TO: Town of Warrenton, Community Development
FROM: Jim Madison, P.E.
DATE: April 30, 2025
RE: Warrenton Crossing II
Exception Petition
LDC Project #24079-1-1

Re: Daniels Property – Legislative Waiver 1st Review
Comment Response Letter
#LWAV-25-2
LDC Project #24079-1-1

Re: Daniels Property
Comment Response Letter
Legislative Waiver 1st Review
LDC Project #24079-1-1

PRELIMINARY LAYOUT

VICINITY MAP

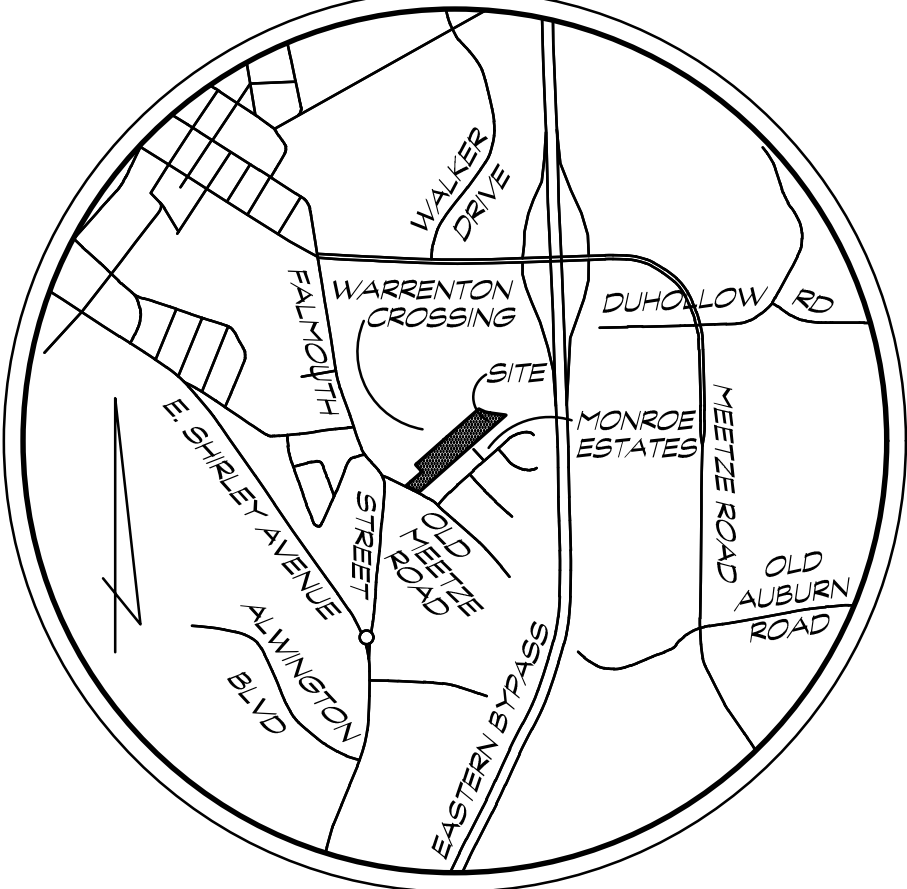
Code/Code Section/Detail	Comment:
1.		<p>Comment: Revise the vicinity map so that the Warrenton Crossing and Monroe Estates subdivisions are labeled so as to provide context for this proposed subdivision. The scale of the vicinity map may be reasonably adjusted as needed for legibility.</p> <p>Response: The vicinity map has been revised to show Warrenton Crossing and Monroe Estates.</p>

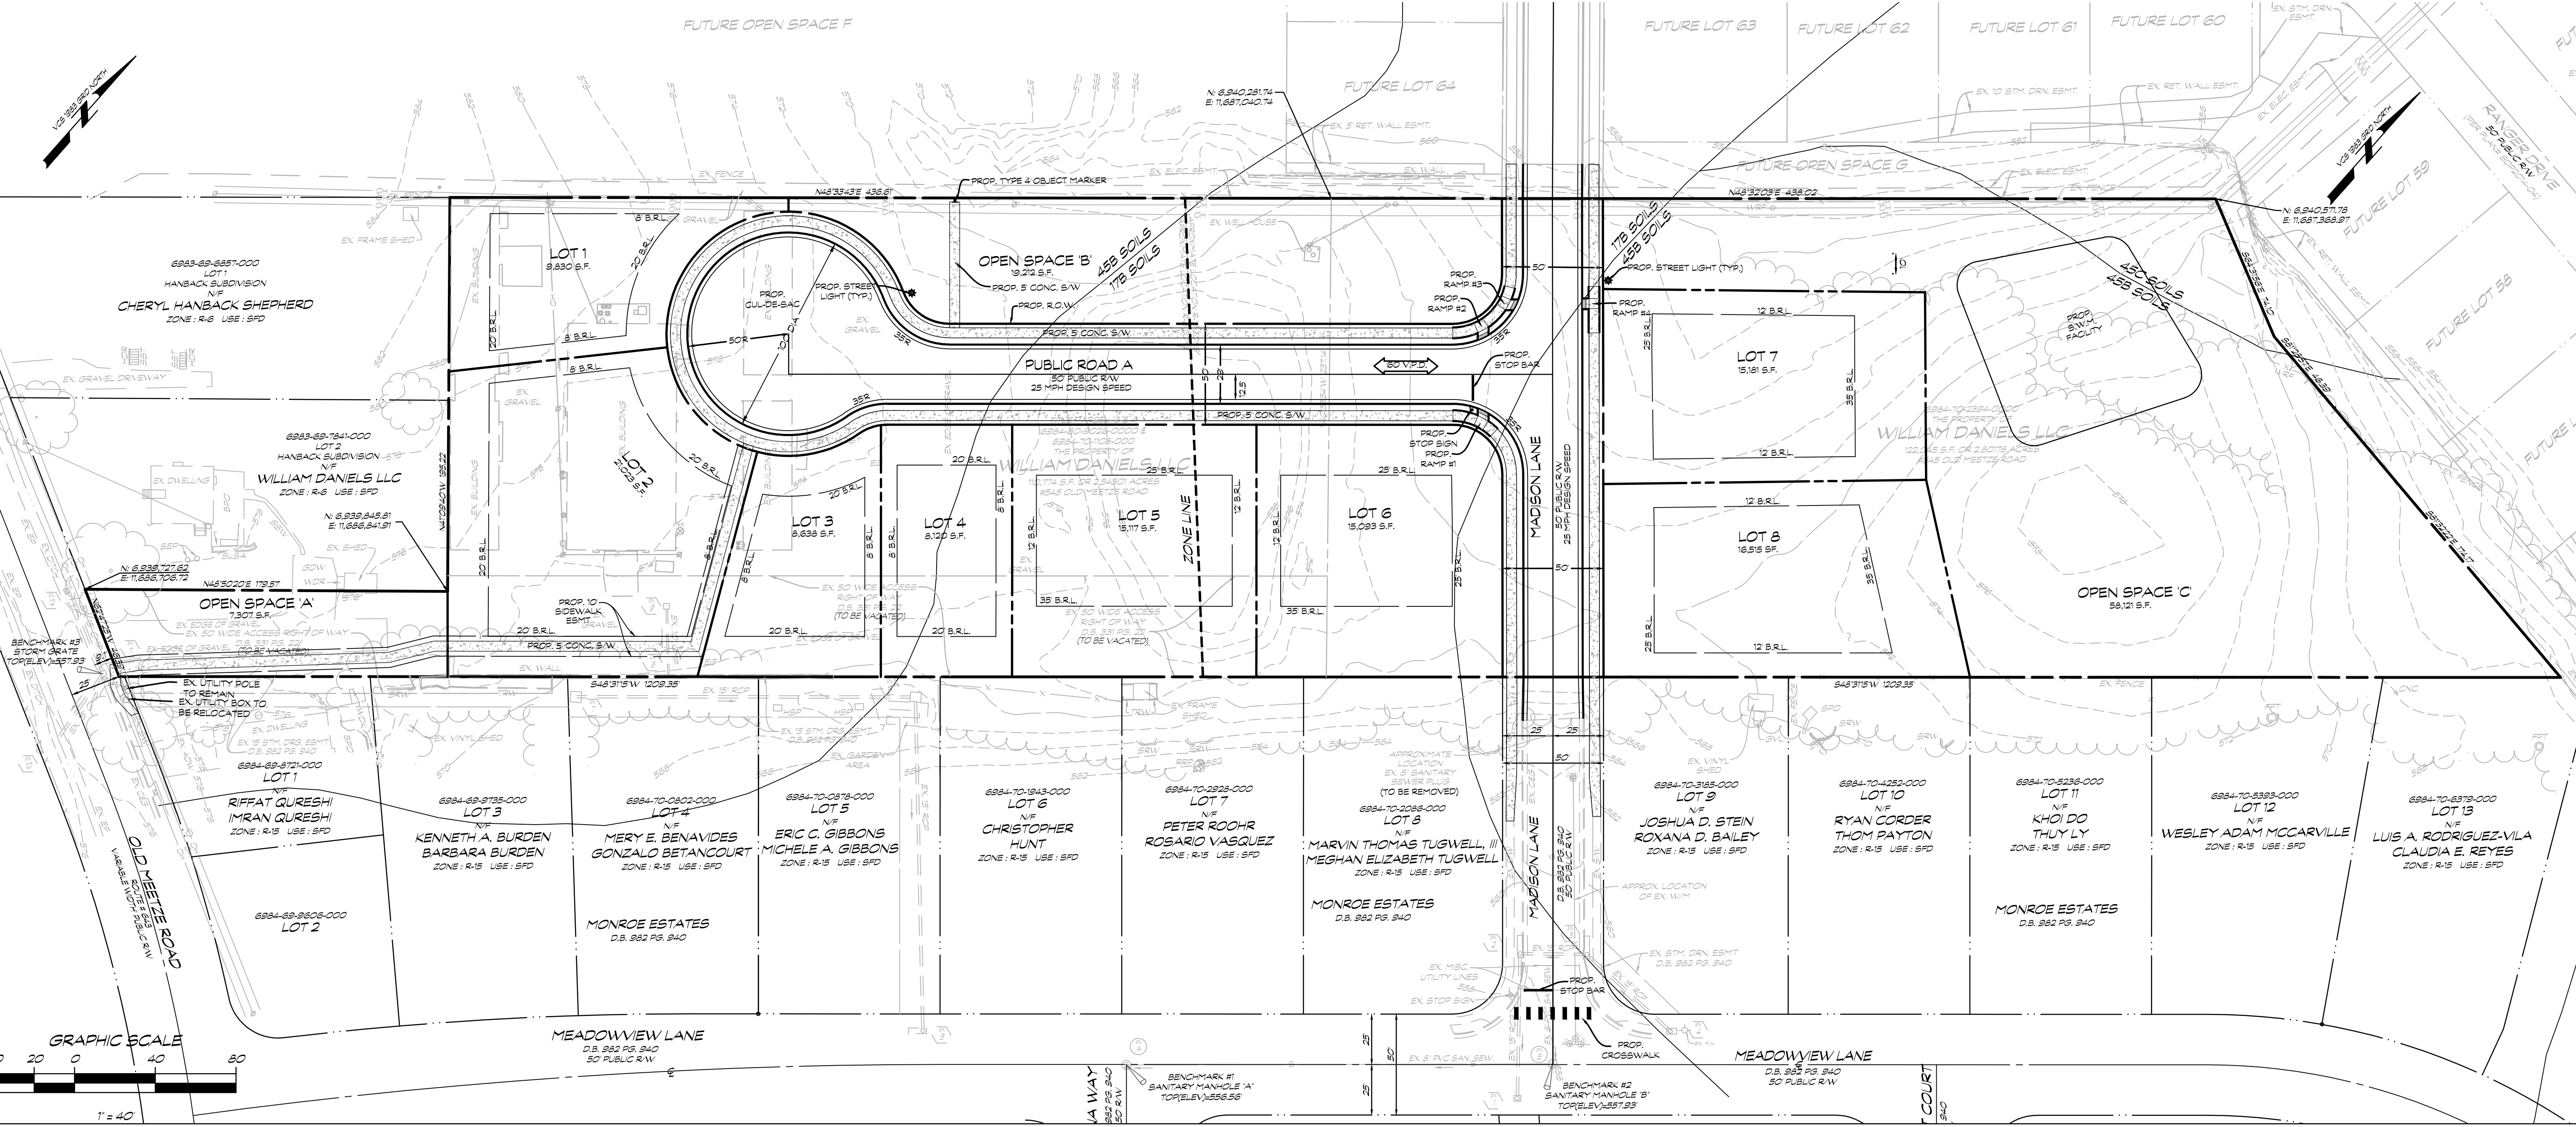
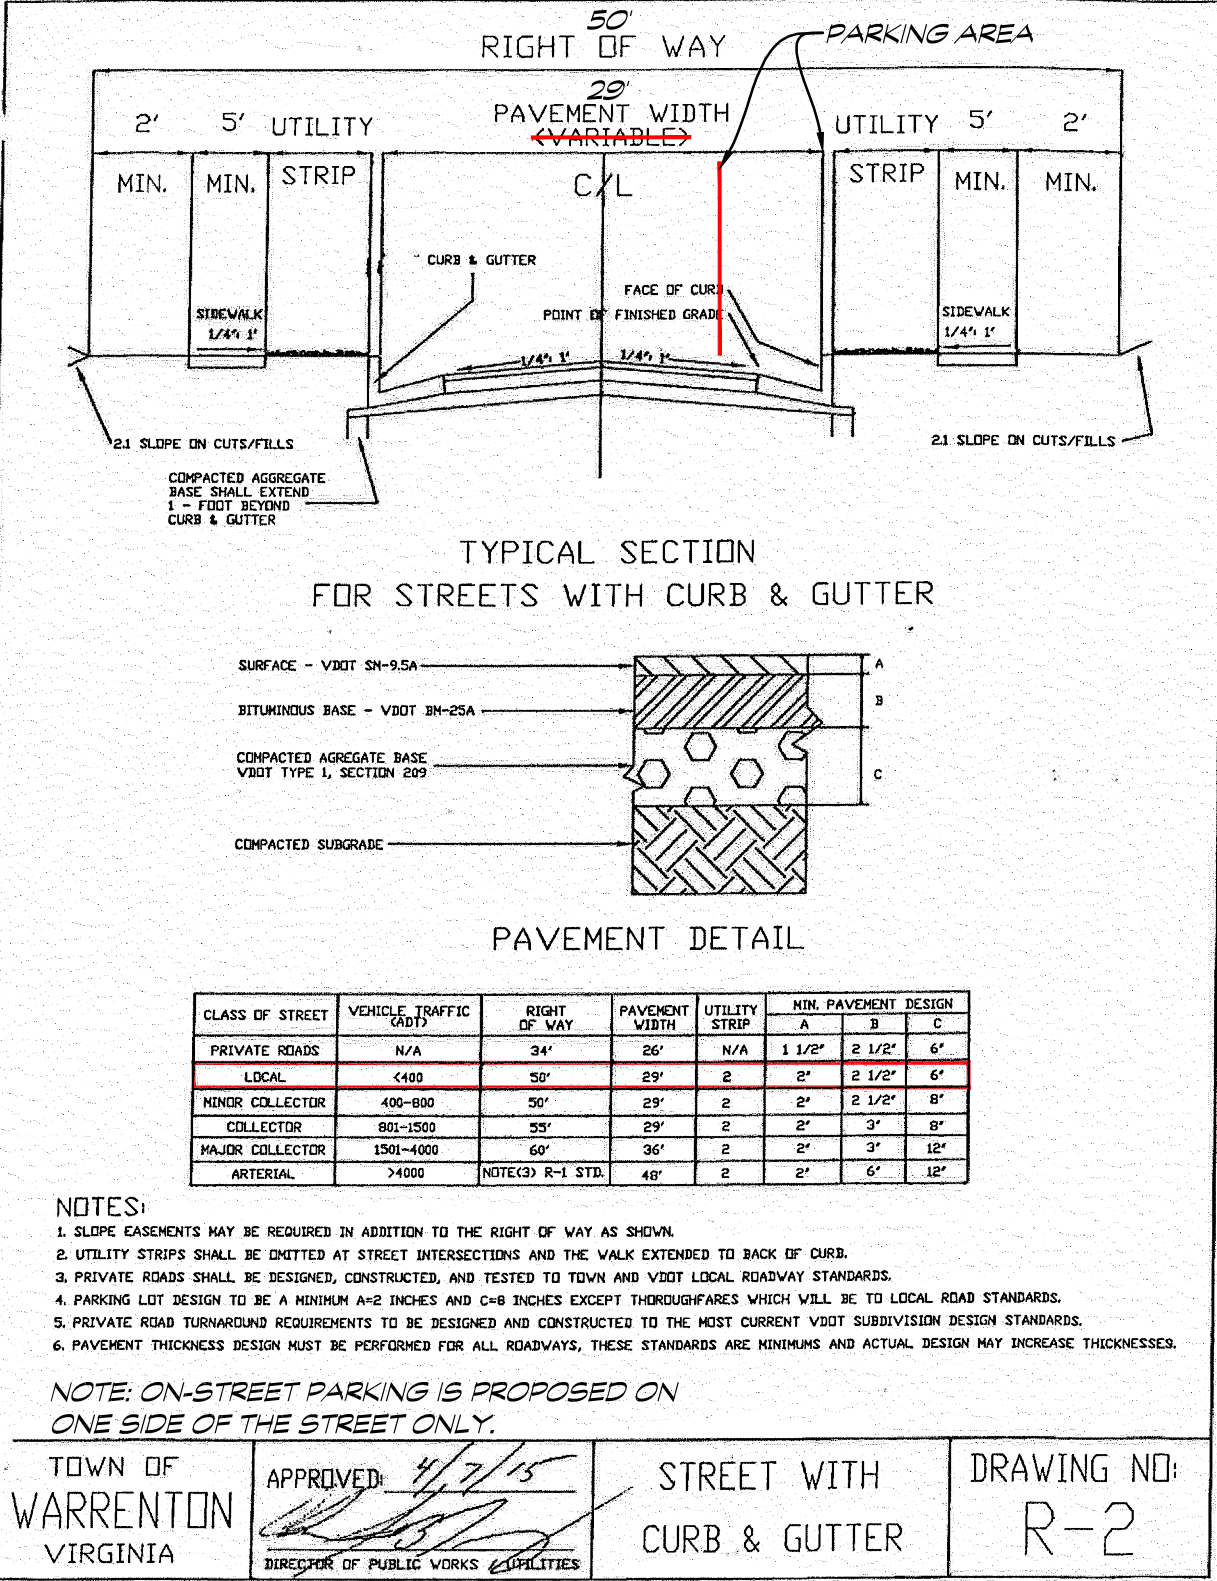
2.		<p>Comment: Show the proposed lots, open spaces, and other improvements that are part of the Warrenton Crossing subdivision development (light/faded or dashed linework, etc.) where these improvements directly abut the Daniels Property subdivision; provide labels as needed.</p> <p>Response: Agreed and provided.</p>

3.		<p>Comment: Provide a typical cross-section of the proposed roadways A and B (may be the same cross-section if applicable); provide dimensions for roadway and right-of-way width, and state whether on-street parking is accommodated (one or both sides, or no street parking).</p> <p>Response: Typical cross section for Public Road A and Madison Lane has been provided. On-street parking is being proposed on one side of the road.</p>

4.	4.11 SO	<p>Comment: Show a connection of new sidewalk to the existing sidewalk on Madison Lane as curb, gutter, and sidewalk are required in all subdivisions.</p> <p>Response: Agreed and provided.</p>

5.		<p>Comment: The applicant should consider a pedestrian connection from the proposed subdivision to Old Meetze Road through "Outlot A" to allow convenient pedestrian access to Old Town areas.</p> <p>Response: Agreed and revised. New sidewalk has been added to connect to Old Meetze Road sidewalk.</p>

6.		<p>Comment: Show stop signs and stop bars at the intersection of "Public Road A" and "Public Road B".</p> <p>Response: Stop sign and stop bar were provided at the intersection of Public Road A and Madison Lane.</p>

9.	4.2.8 SO	<p>Comment: The names of existing streets may not be changed except by approval of the Town Council. Revise the plan to show "Public Road B" as Madison Lane. Staff notes that the proposed stub "Campbell Lane" as shown on the Warrenton Crossing plan will need to be revised to also reflect the Madison Lane street name.</p> <p>Response: Public Road B has been revised to Madison Lane as suggested.</p>

11.	4.17 SO	<p>Comment: Street lighting must be installed along all public streets; the plan does not currently show locations of proposed street lighting. This comment may be addressed by either amending the plan view or adding a note.</p> <p>Response: Agreed and provided. 2 street light locations were shown on the plan.</p>

12.	4.2.10 SO	<p>Comment: Provide the diameter measurement for the proposed cul-de-sac on the plan. The diameter must be a minimum of 100' and may have a landscaped island in the center.</p> <p>Response: Agreed and provided. The radius of the proposed cul-de-sac (50') was labelled on the plan.</p>

13.		<p>Comment: The existing 50' right of way easement shown as "Outlot A" and across lots 2-6 must be vacated as part of the plat process for the subdivision; label the easement as "To Be Vacated".</p> <p>Response: Agreed and labelled.</p>

14.	4.3.2 SO	<p>Comment: Outlots are prohibited in subdivisions. Outlots A, B, and C may be utilized as "open space" or reconfigured to be absorbed into the adjacent proposed lots.</p> <p>Response: Agreed and revised.</p>
